response to adequacy review #3 - PVRE Pit #1 M-2017-009

RE: PVRE Pit #1, M-2017-009, New 110 Construction Materials Reclamation Permit Application, Adequacy Review No. 3

EXHIBIT E - MINING PLAN

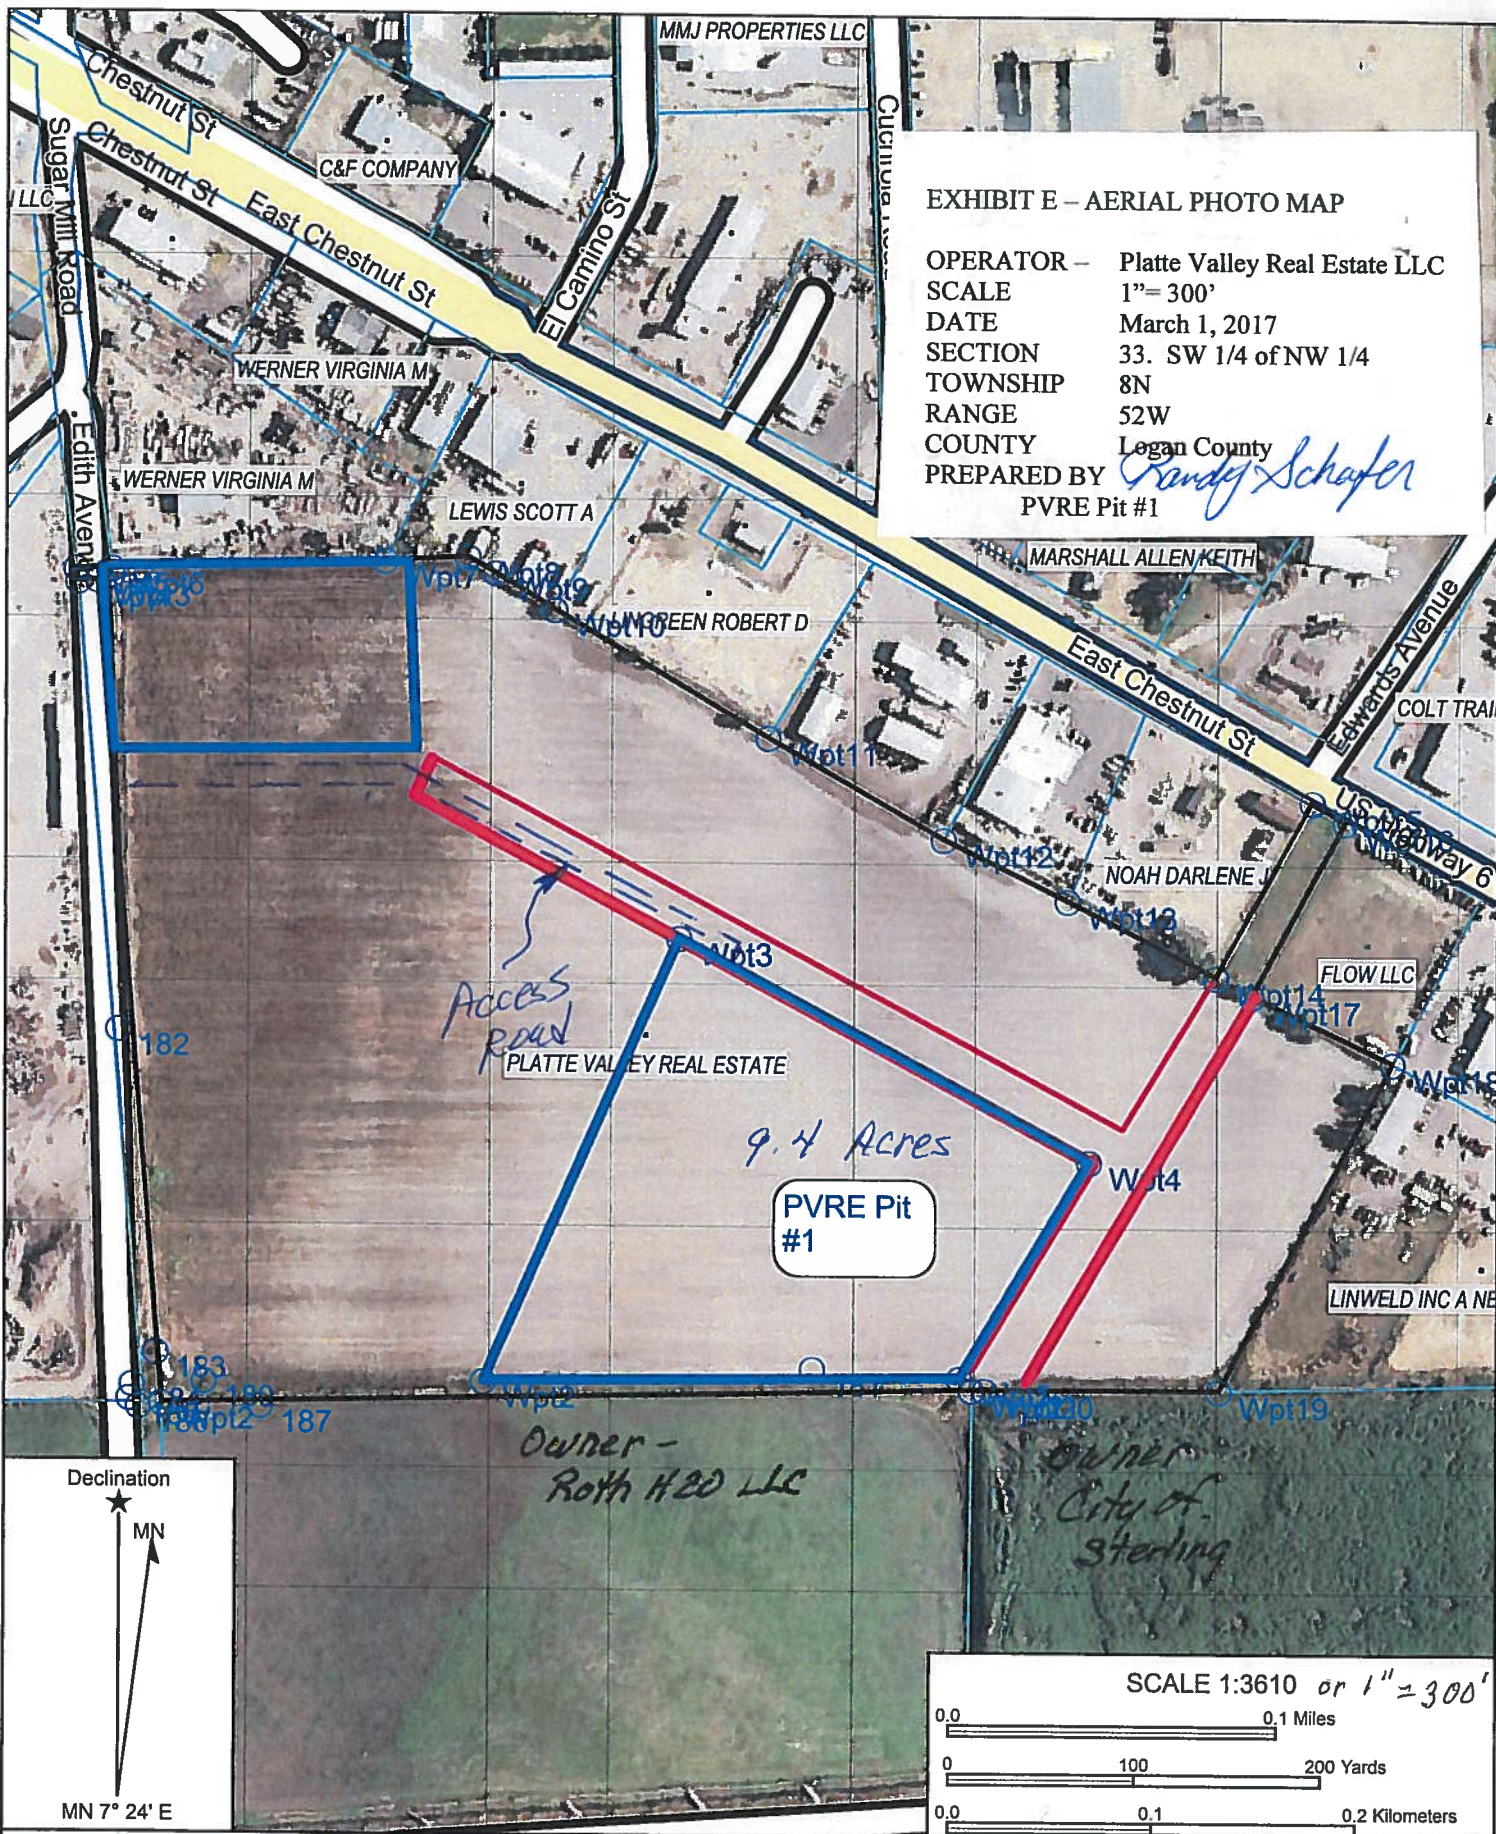
10) Has “Jack’s Lane” been constructed? If so, please provide a description of this road and a picture of this road and indicate if the road will be improved to support the mining operation. Based on the definition of “Affected Land” in Rule 1.1(3), roads must be included as affected land unless the road existed prior to the date on which a permit application was made to the Office and which was constructed for purposes unrelated to the proposed mining operation and which will not be substantially upgraded to support the mining operation. Also, per Rule 6.3.3(g), new or improved roads must be included as part of the permitted acreage. If the road does not exist, it must be included in permit acreage, and given that the proposed permit area is already 9.9 acres including this road would require the applicant to withdraw this 110 Limited Impact Operation application and submit a 112 application or reduce the proposed permit area below the 10 acre Limited Impact Operation threshold.

b. *DRMS Response:* Per Rule 1.1(3) and 6.3.3(g), new or improved roads must be included as part of the permitted acreage. C.R.S. 34-32.5-103(1) states for a road not be considered as part of the affected land it must have been in existence before a permit application was filed with the office. As this road is not currently in existence, the acreage associated with it must be included in the permit acreage/affected land acreage. Since the proposed permit area is already 9.9 acres including this road would require the applicant to withdraw this 110 Limited Impact Operation application and submit a 112 application or reduce the proposed permit area below the 10 acre Limited Impact Operation threshold while including the road acreage. If the latter option is chosen, the applicant will need to file a Technical Revision to the application in accordance with Rule 1.8. The revision shall include revised application Exhibits as applicable to account for including the road area within the permit boundary.

We will continue to complete the requirements for a 110 application. The permitted acreage will be changed to include Jack’s Lane from the NW corner of the pit to Edith Road. The roadway itself will be 20’ by 1050’ or approximately 0.5 acre. The affected pit area will be reduced to 9.4 acres. Maps will be revised and included as necessary.

EXHIBIT E - RECLAMATION PLAN

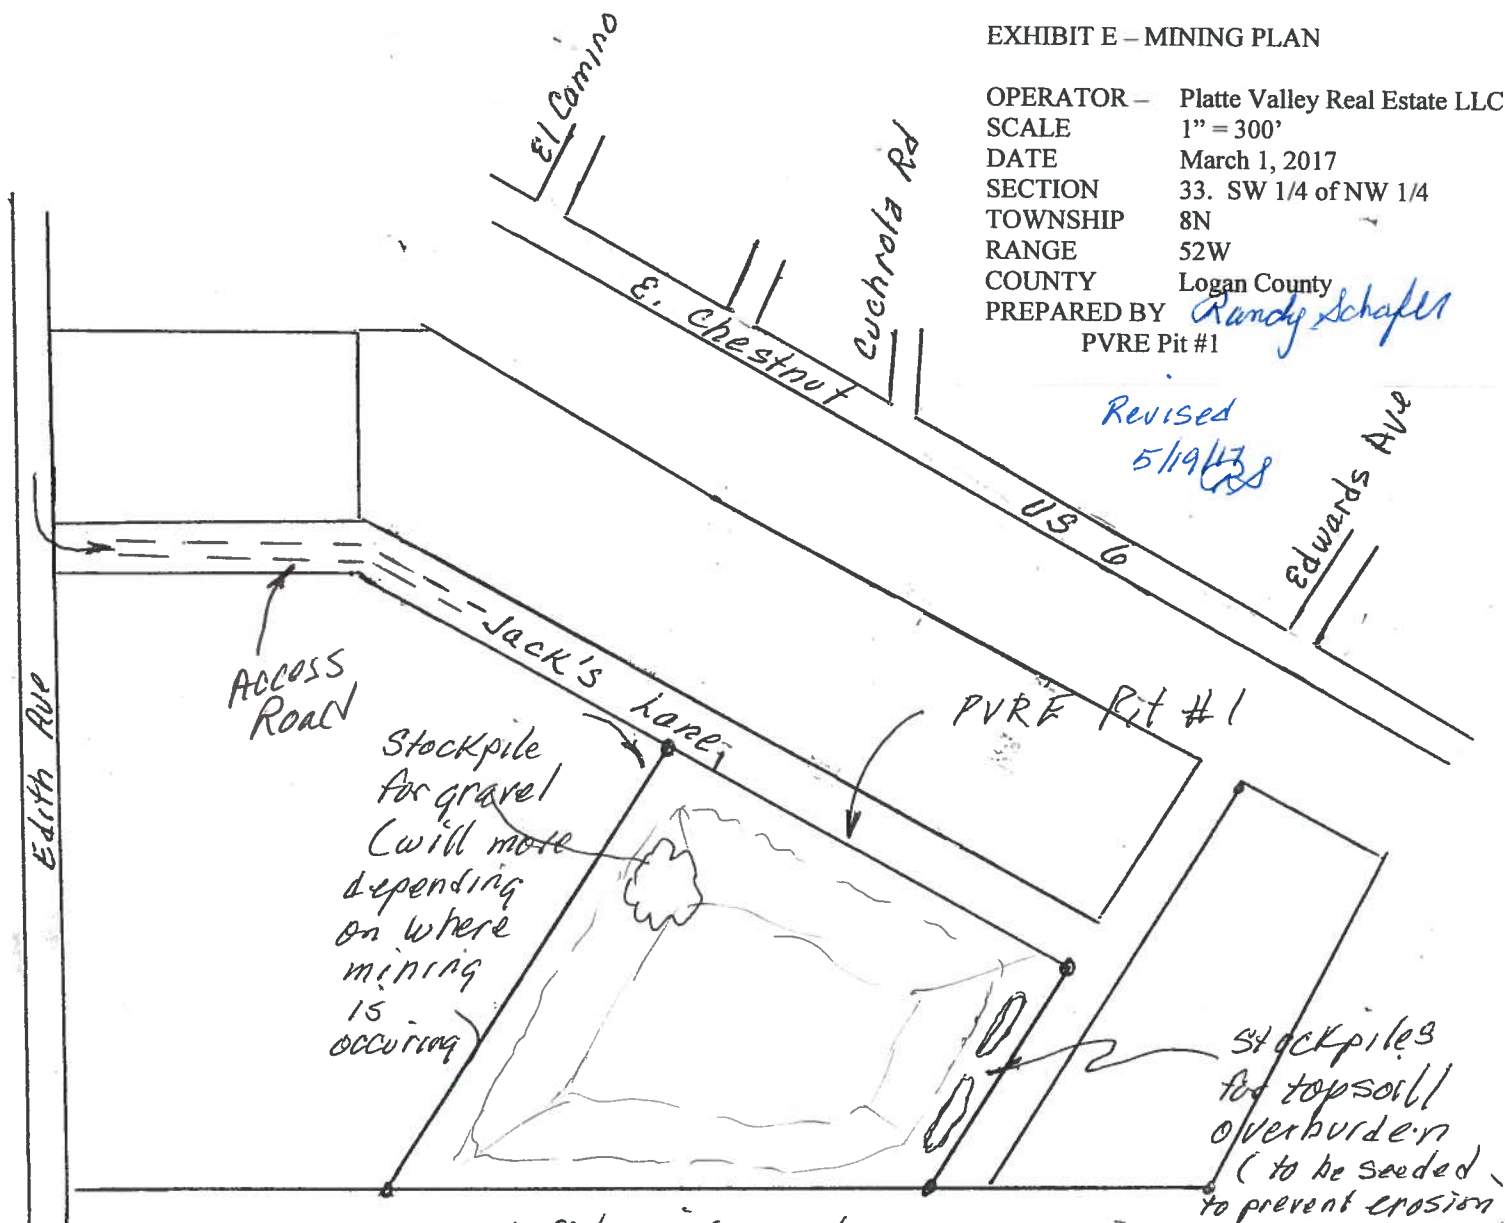
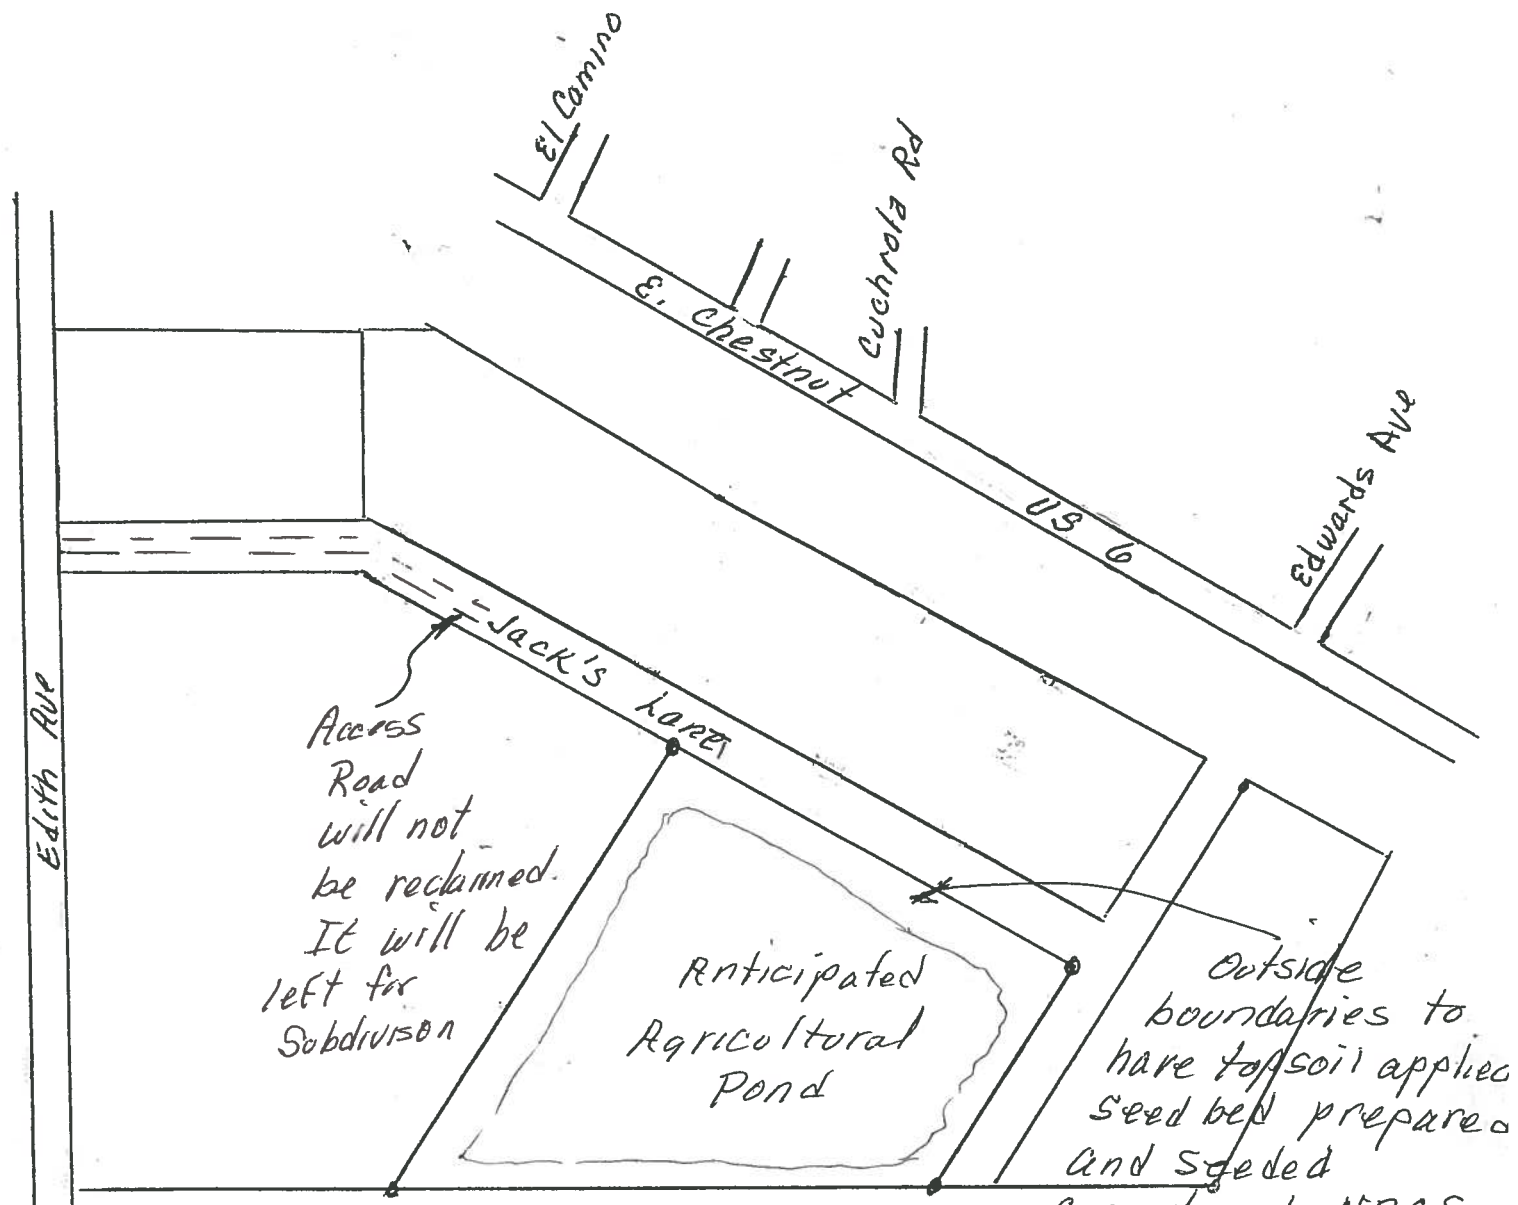
c. The reclamation plan indicates the entire pit area will have overburden and topsoil replaced. The cost estimate only estimates that cost to replace topsoil over 2.4 acres. Please revise the estimate for topsoil replacement to cover the entire 9.9 acre affected area with topsoil.

e. Please revise the estimate for revegetation for the entire 9.9 acre affected area.

We will submit a revised cost estimate based on 9.4 acres. The 0.5-acre roadway will not be reclaimed. It will be a permanent roadway serving the newly created subdivision known as Platte Valley Industrial Park. We recognize that we can seek a surety reduction once a permanent plan of augmentation is in place.

Our revised cost estimate will include revegetation of 9.4 acres. The roadway will not be revegetated. It is a permanent roadway serving the newly created subdivision known as Platte Valley Industrial Park.
